Addendum No. 1

ADDENDUM NO. 01

Dixieland Elementary School Portable Building
Madera, CA 93637
Client Bid No: 031623

DARDEN PROJECT NO. 2212
DSA File No. 20-30
DSA APPL. NO. 02-120058

A1	Site Gate Schedule	A11	ORNAMENTAL METAL, Footing	A14	ORNAMENTAL METAL, Sill Section
N.T.S.		3/4" = 1'-0"		3" = 1'-0"

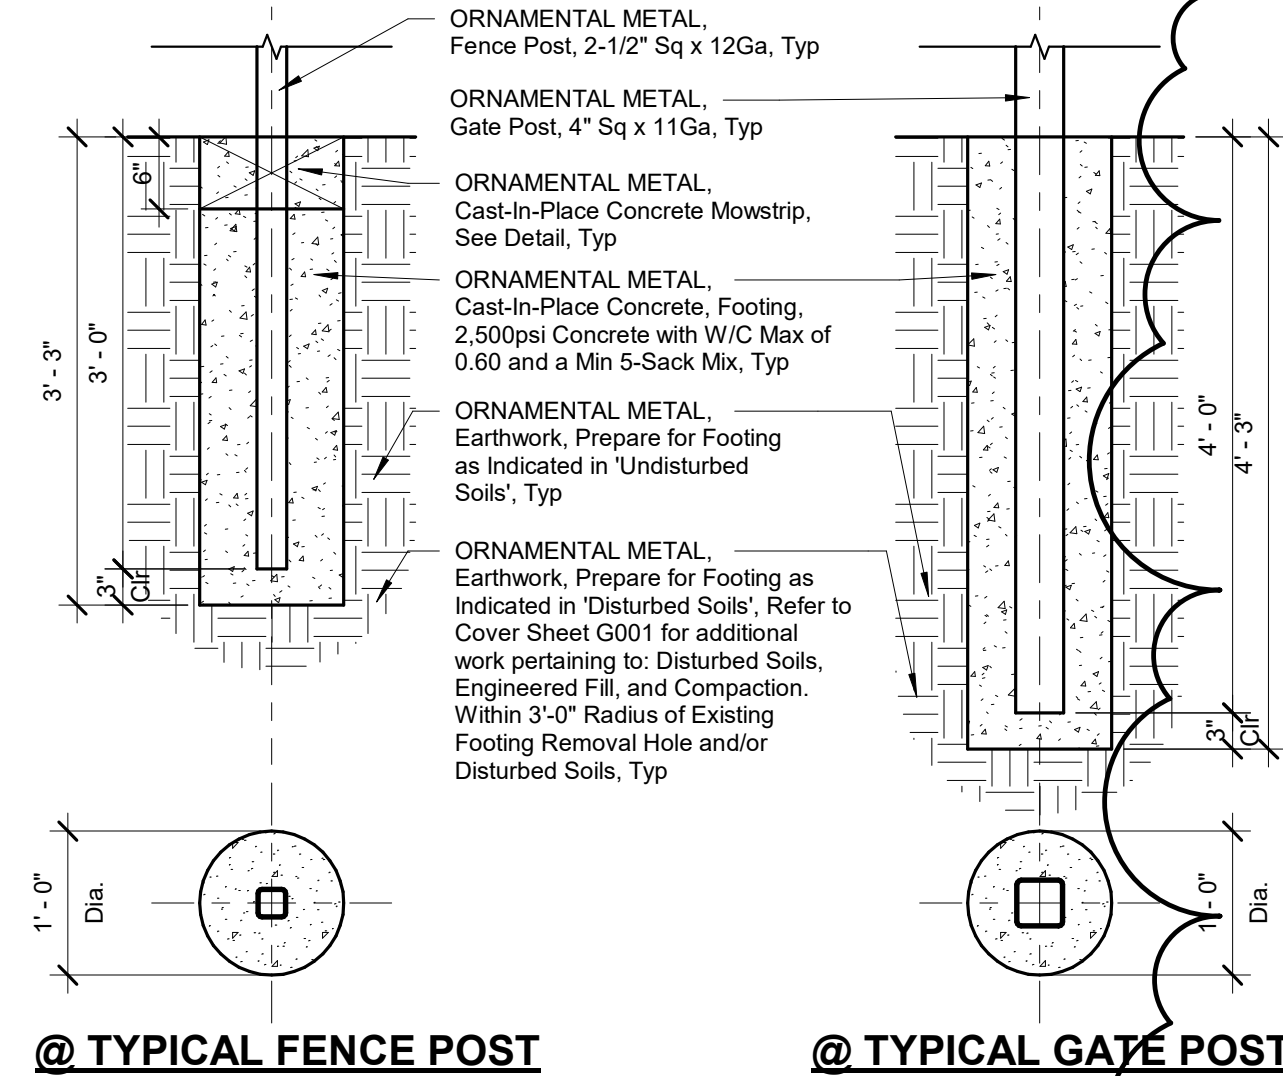
AD1-A01 Refer to Sheet SD/A104, ORNAMENTAL METAL DETAILS:

1. Refer to SD/A104, Detail A14 - Ornamental Metal, Sill Section and revise as shown per the attached AD1-AX01. Changes are shown in clouded area(s).
